TITLE: MB FUSION

DRAWING NO: 406-0540-C1

COMPANY: GALLIEN-KRUEGER

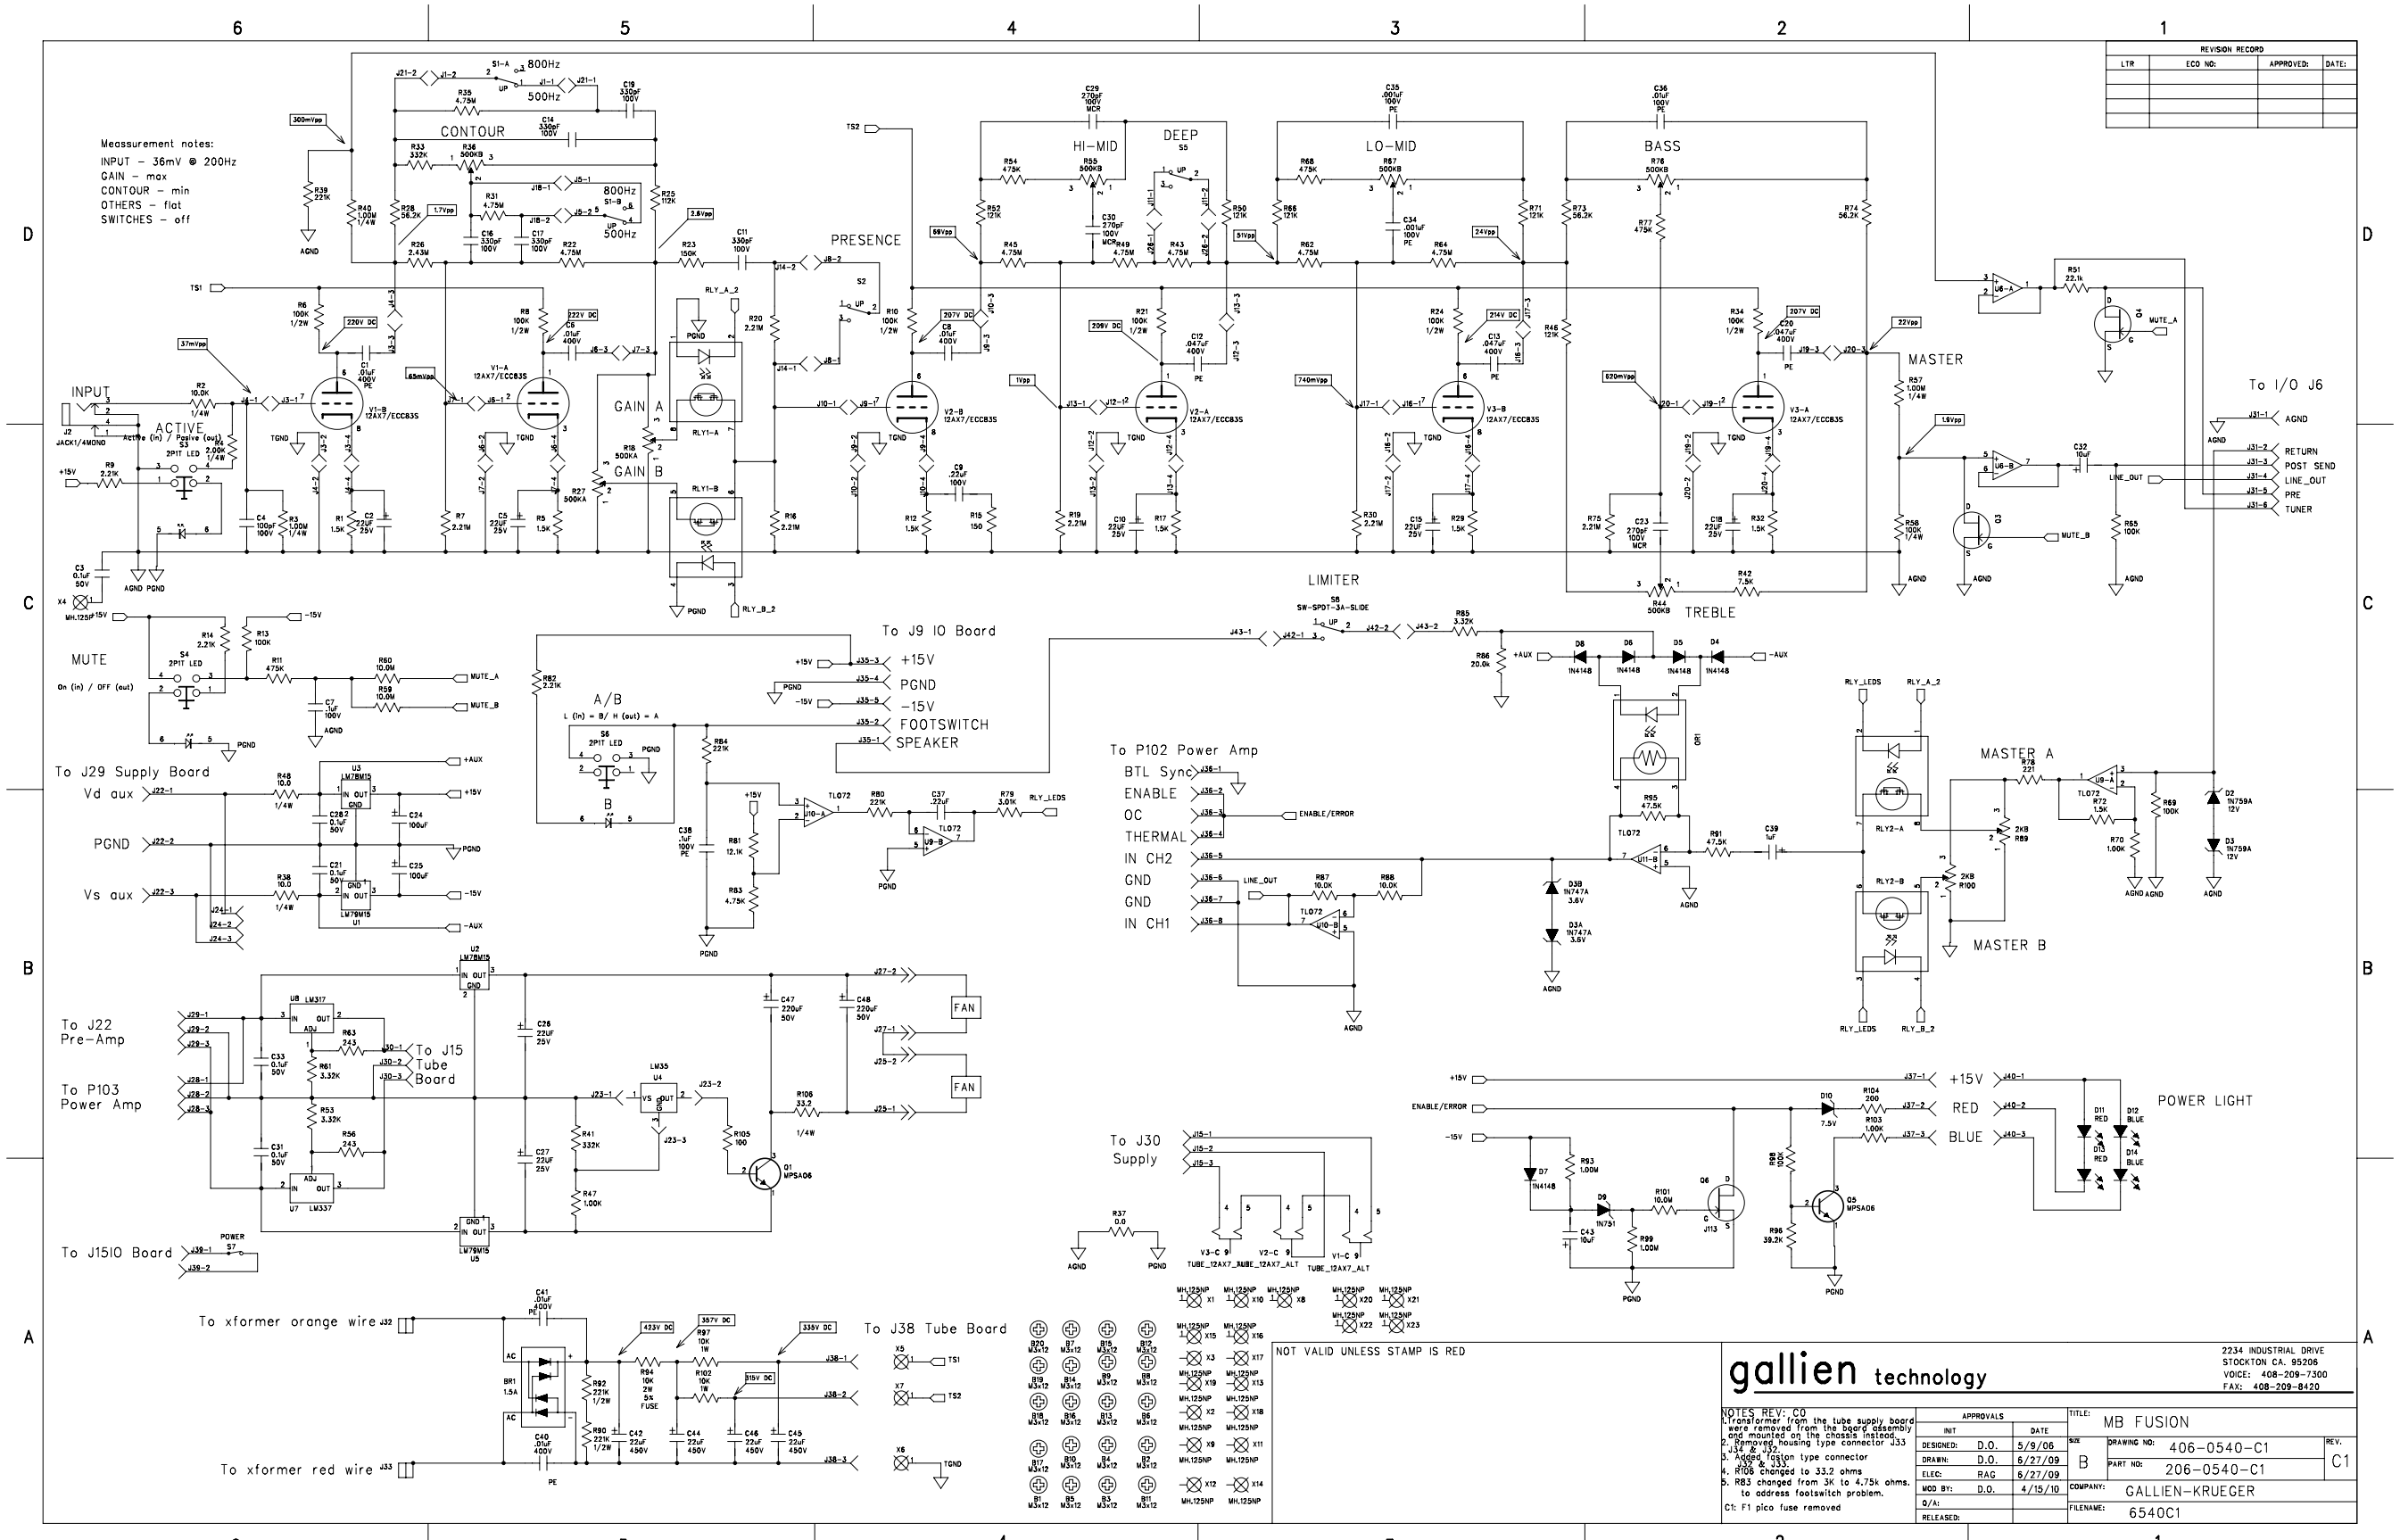
NOTES REV: C0
1. Transformer from the tube supply board were removed from the board assembly and mounted on the chassis instead.
2. Removed housing type connector J33 J34 & J32.
3. Added fusion type connector J32 & J33.
4. R106 changed to 33.2 ohms
5. R83 changed from 3K to 4.75k ohms. to address footswitch problem.
C1: F1 pico fuse removed
